2021 & Newer Ford F150 Undercarriage LTA25150 Revised to LTA25150B

SERVICE BULLETIN

Affected Unit	Model Number(s)	Description	Serial Number(s)
	LTA25150B	UC/RT3,HTX,FORD F150,21+	400000000+

Old Skid Plate – LTA10122-03

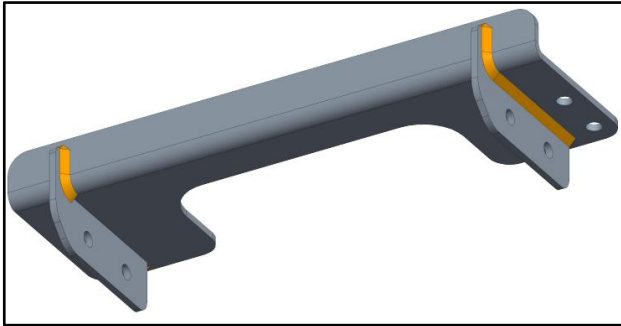
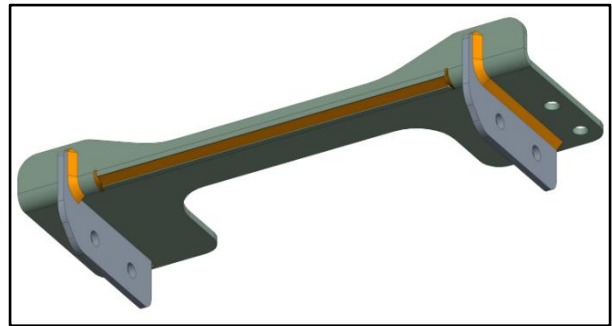
To accommodate a frame variation on a specific trim level of 2021 & Newer Ford F150 trucks (163" Wheelbase - Super Crew with 8' box frame only), BOSS has revised the LTA25150 undercarriage to **LTA25150B**. The LTA25150B undercarriage will retrofit back to 2021 model year trucks. Crossmember variation on the specific truck listed above has prompted a change to the skid plate bracket shown below. A cutout has been added to clear this crossmember across all trim levels. Existing LTA25150 (non-B kits) are usable on all other trim levels except for listed above through the 2023 model year.
